**Spare Parts Requirements - Inner Actuating Mechanism for Rear Door Opener:  
Particular Points to Note (117/18)**

Model Line: **Cayenne (92A)**

Model Year: **As of 2011 up to 2018**

Subject: **Rear door opener**

*Removing switch for central locking system*

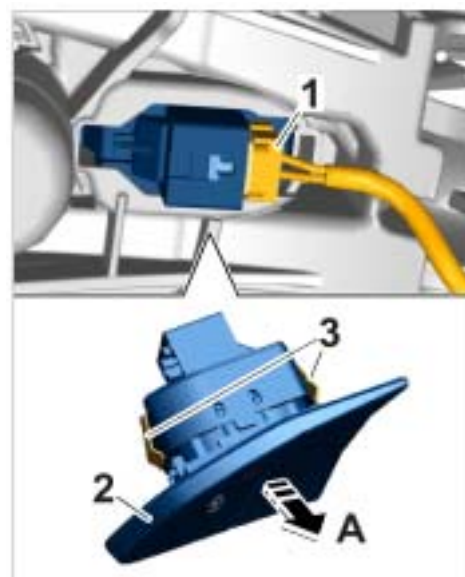
**If the inner actuating mechanism for the rear door opener needs to be replaced, the new component to be used from now on will (always, irrespective of requirements) have a switch for the central locking system installed (⇒ Removing switch for central locking system -item 2-).**

The **switch for the central locking system is not required when using the rear inner actuating mechanism** and must be **replaced** accordingly **by a trim cover** (958.555.247.02 - left/958.555.248.02 - right), see ⇒ *Workshop Manual '577819 Switch for central locking system'*.

- Parts Info:
- 958.555.019.03 GOB ⇒ Inner actuating mechanism (left)
  - 970.555.523.01 1E0 ⇒ Trim cover (for inner actuating mechanism - left)
  - 958.555.020.03 GOB ⇒ Inner actuating mechanism (right)
  - 970.555.524.00 1E0 ⇒ Trim cover (for inner actuating mechanism - right)
